# Modification Report

Westlink Industry Park - Stage 1 (Modification 6)

1030-1048 & 1050-1064 Mamre Road, 59-62 & 63 Abbotts Road, 290-308 Aldington Road, Kemps Creek

4 March 2025 | 2200446

**Figure 5** Comparison of Approved and Proposed Lot 3 Site Plan

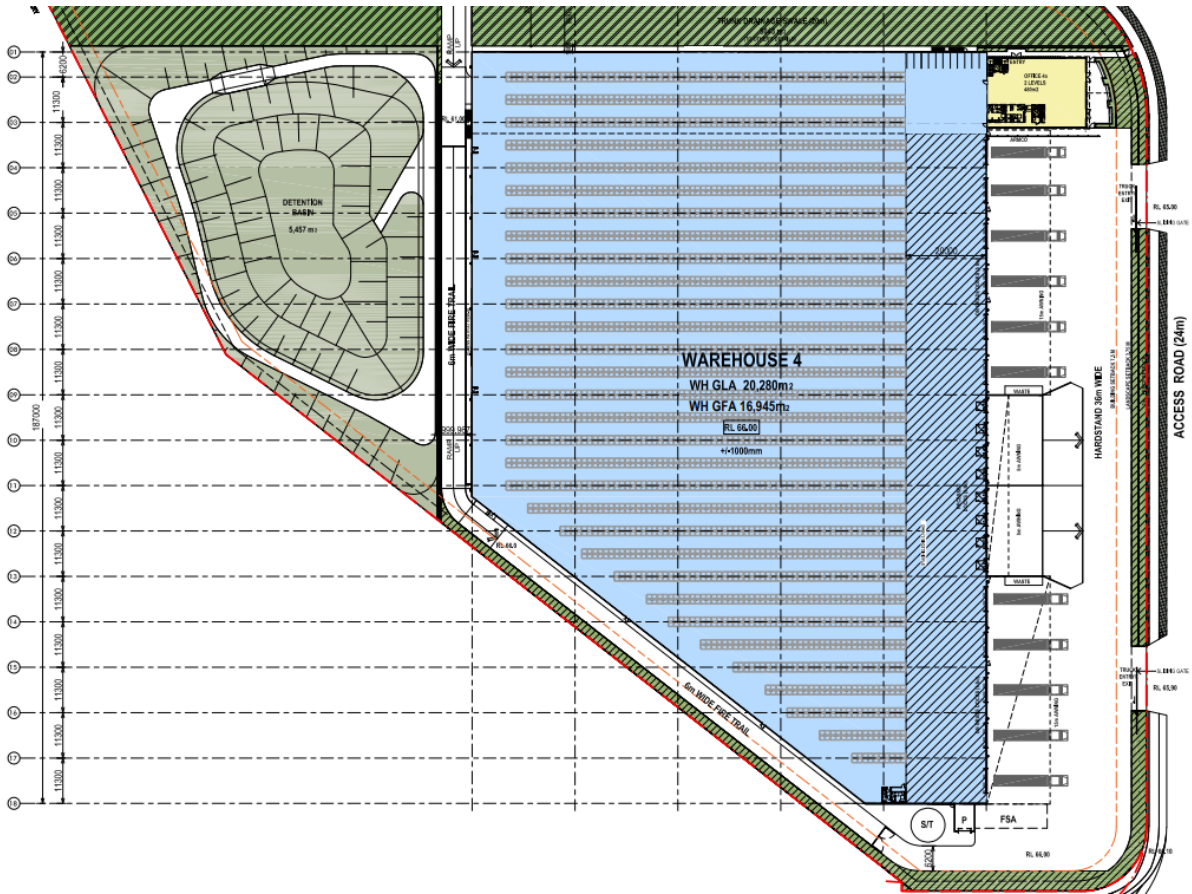
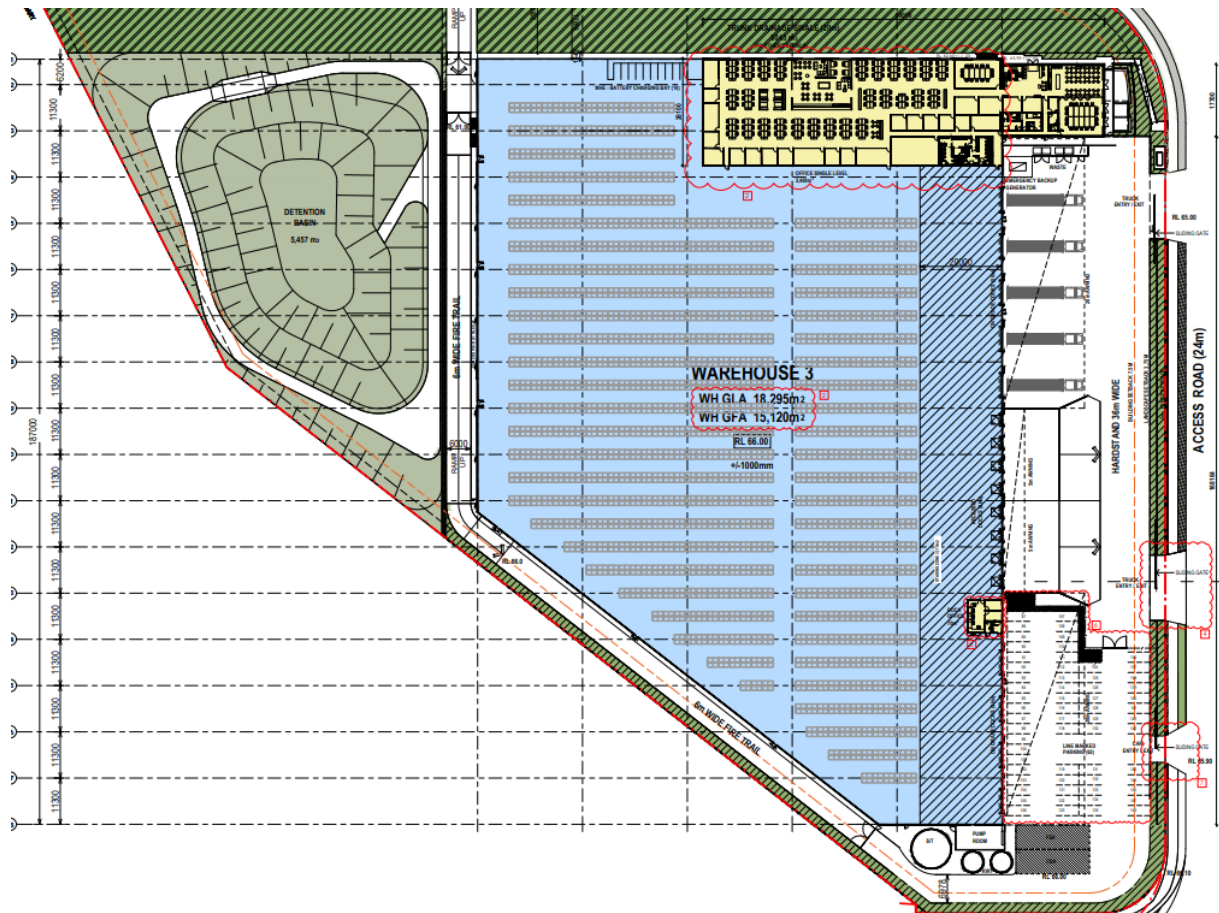
A comparison of the key approved development and proposed modification components is provided in **Table 5**, with a comparison of the approved and proposed Lot 3 Site Plan provided in **Figure 5** on the following page.

**Figure 6 Comparison of Approved and Proposed Lot 3 Office Footprint**

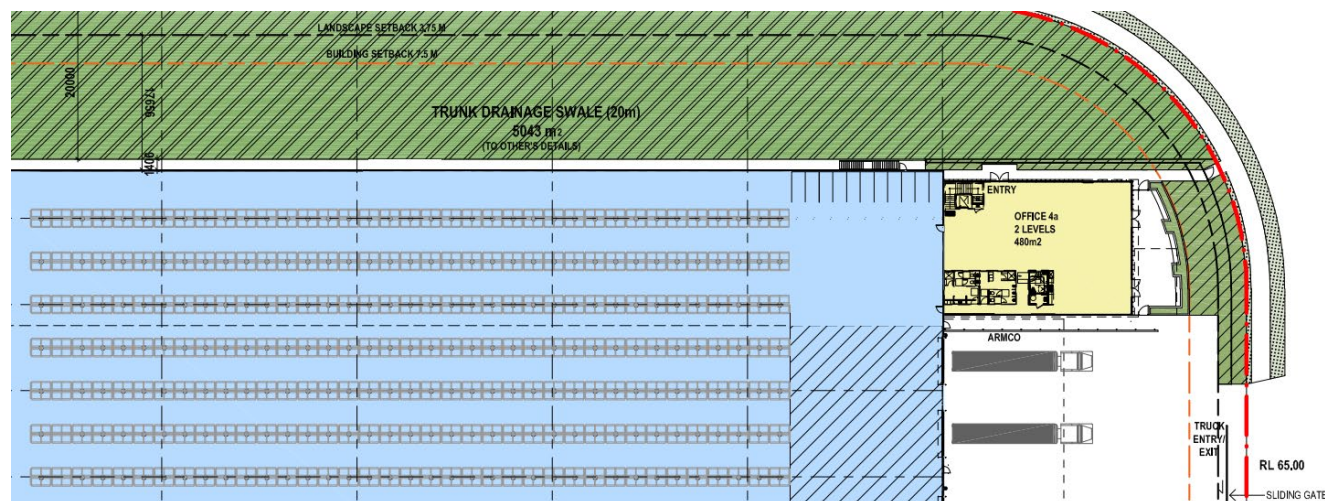
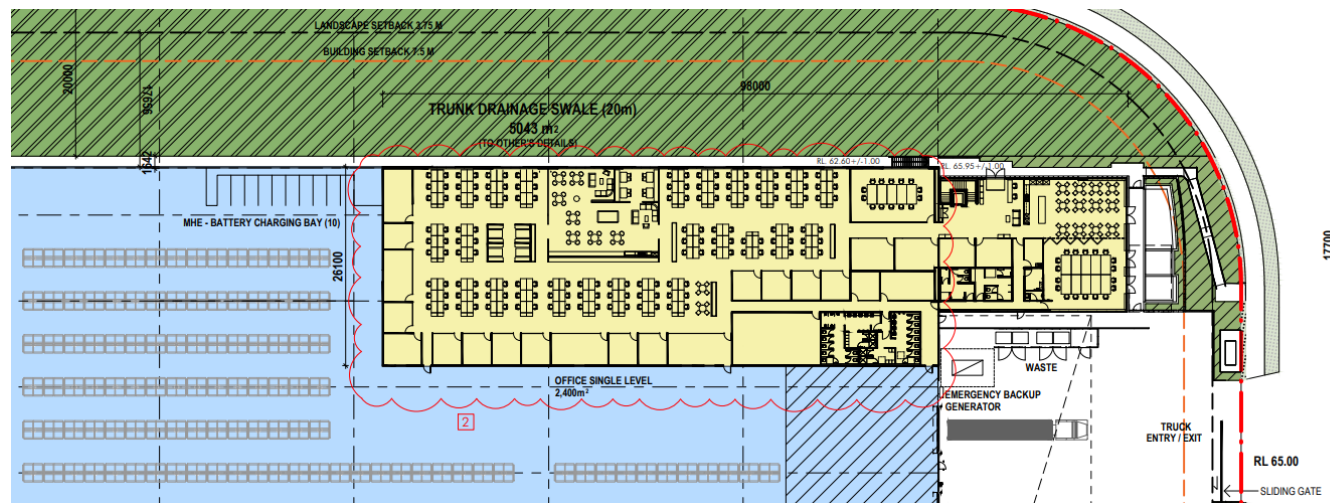
The proposed modifications seek to expand the ancillary office area from 480m<sup>2</sup> to 2,400m<sup>2</sup> (+1,920m<sup>2</sup>) to facilitate the operational requirements of the future customer. It will support the provision of larger workstations, enhanced recreational and break areas, and improved staff amenities.

The proposed changes to the ancillary office area includes the conversion of the north-eastern corner of the warehouse to an expanded single-level ancillary office area. The expanded office area includes a large open office area with dedicated office areas and meeting rooms throughout, as well as a large amount of staff amenities including large lunch and collaboration areas and a gym. Further, natural light will be provided through windows to the north and south within the warehouse. A comparative illustration of the approved and proposed office space footprints and layout is provided in **Figure 6** below.

**Figure 7 Comparison of Approved and Proposed Warehouse 3 Northern Elevation**

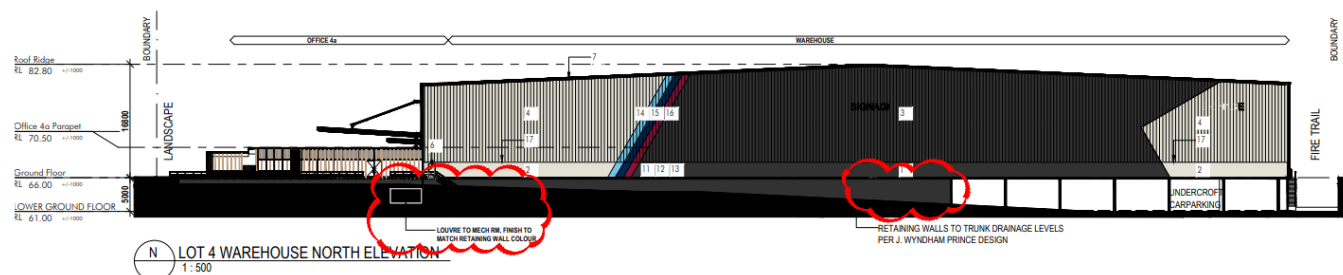
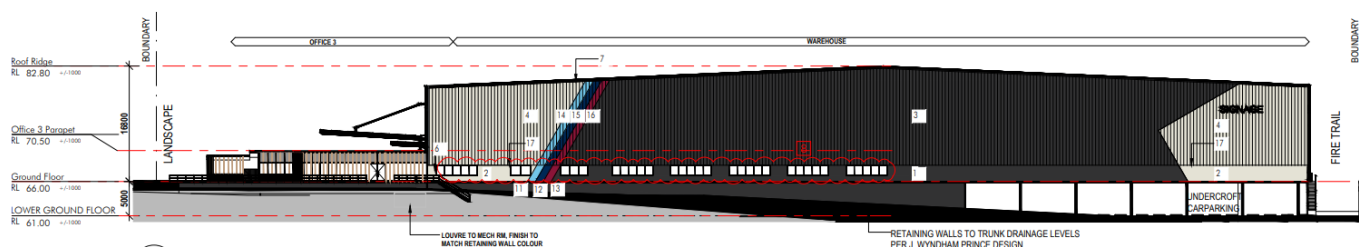
The proposed changes associated with the ancillary office area also include the incorporation of windows along the associated area of the northern elevation. It will enable natural light within the enlarged office area with views of the naturalised trunk drainage channel to be delivered along the northern boundary of Lot 3. A comparative illustration of the approved and proposed northern elevation is provided in **Figure 7** below.

**Figure 8 Comparison of Approved and Proposed Warehouse 3 Site Plan – Dock Office**

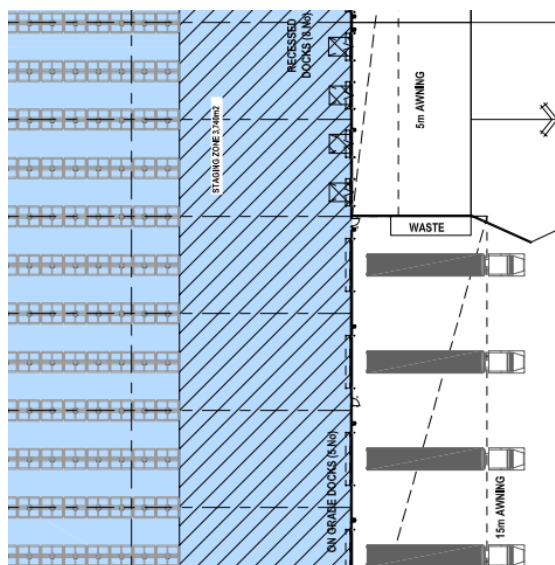
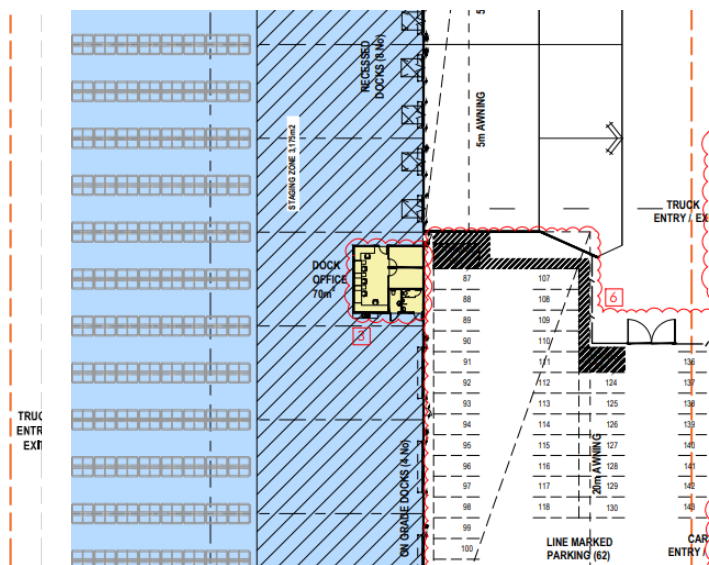
The proposed modifications include the addition of a dock office, as requested by the future customer, to support operations on the loading dock. It includes 70m<sup>2</sup> of ancillary office GFA and will adjoin the eastern warehouse wall, resulting in the removal of one (1) roller shutter door and an increase in overall GFA as it replaces area previously dictated as loading zone area. A comparative illustration of the approved and proposed Lot 3 Site Plan is provided in **Figure 8** below.

**Figure 9 Comparison of Approved and Proposed Warehouse 3 Site Plan – Car Parking and Hardstand**

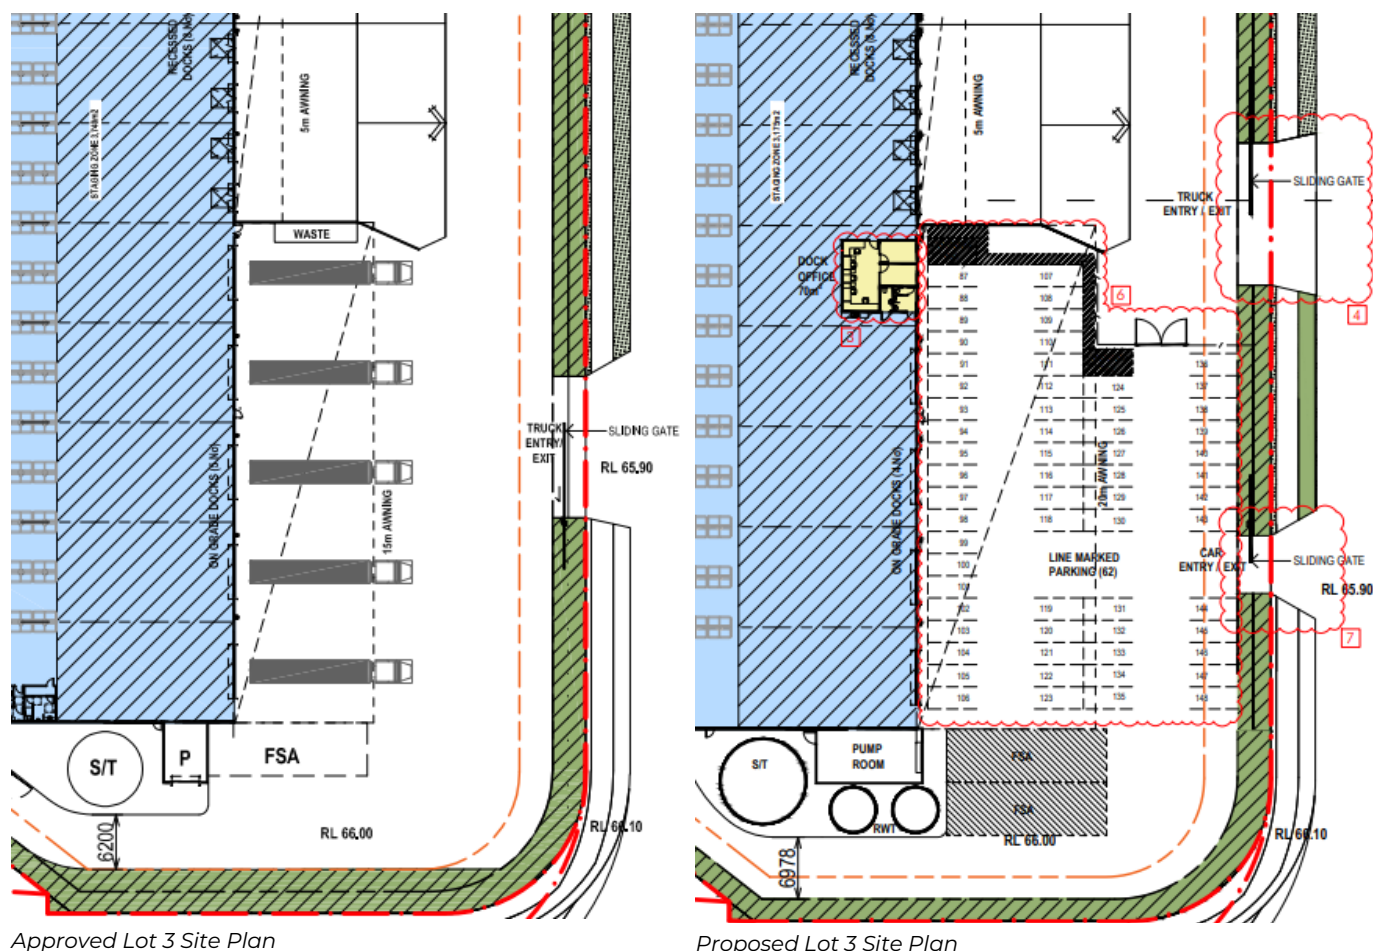
In order to support the additional ancillary office space and the operations of the future customer, the car parking provision is proposed to increase from 85 to 146 (+ 61) car parking spaces. The additional car parking spaces are proposed to be located along the southern portion of the Lot 3 hardstand area, with the area proposed to be converted from a heavy vehicle loading area to a dedicated light vehicle area (refer to **Figure 9**).

A new light vehicle entry/exit driveway is proposed adjacent to the southern portion of the hardstand to support access to the new car parking area. In addition, the approved southern heavy vehicle driveway is proposed to be moved to the north to enable heavy vehicle access that is not impeded by the new car park area. The proposed changes to the driveways has been incorporated onto the amended On-Lot Civil Drawings prepared by AT&L and included at **Appendix E**. As a result of the proposed modifications, minor changes are proposed to the approved landscape design, as depicted in the amended Landscape Drawings prepared by Site Image at **Appendix D**.

A comparative illustration of the approved and proposed southern hardstand and driveway design is presented in **Figure 9** below.

**Figure 10 Pedestrian Access Plan**

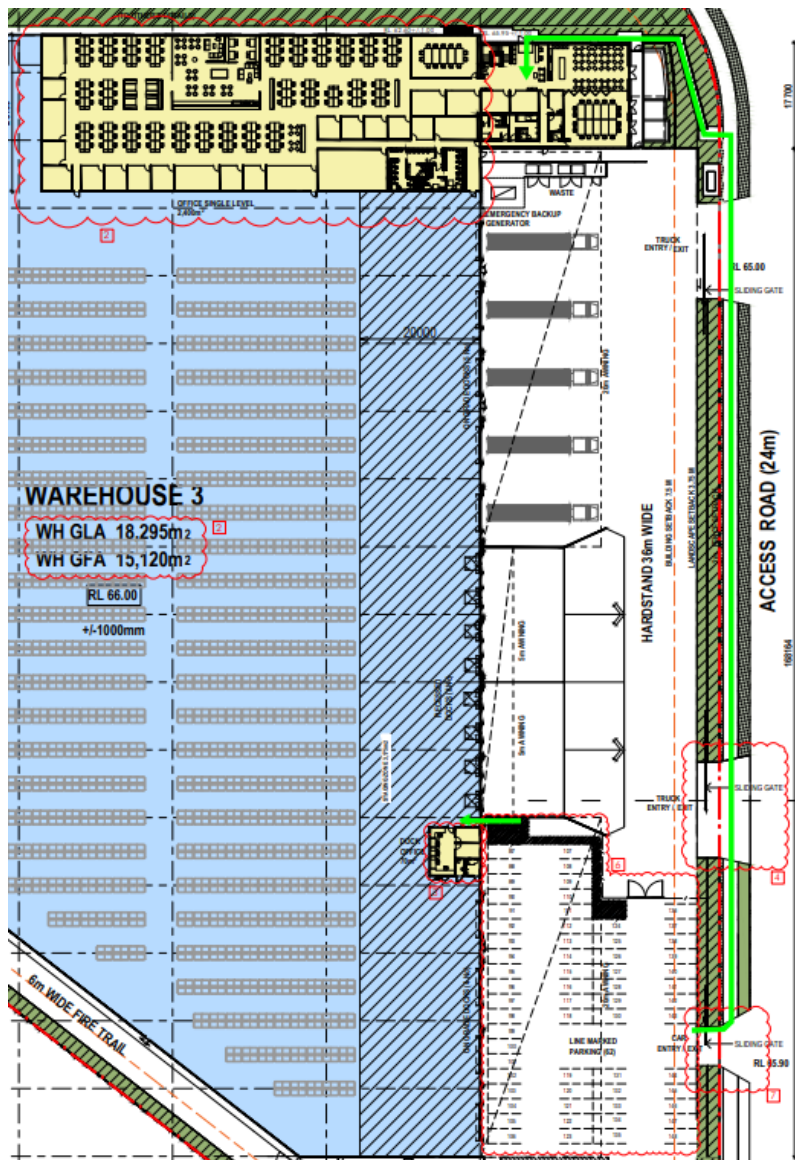
It includes supporting safety features such as fencing to separate the car parking area from the heavy vehicle area and pedestrian access ways to support safe pedestrian access. Pedestrian access from the car parking is available directly to the warehouse adjacent to the dock office, or to the office via the pedestrian pathway along the Access Road to the east, as illustrated in **Figure 10**.
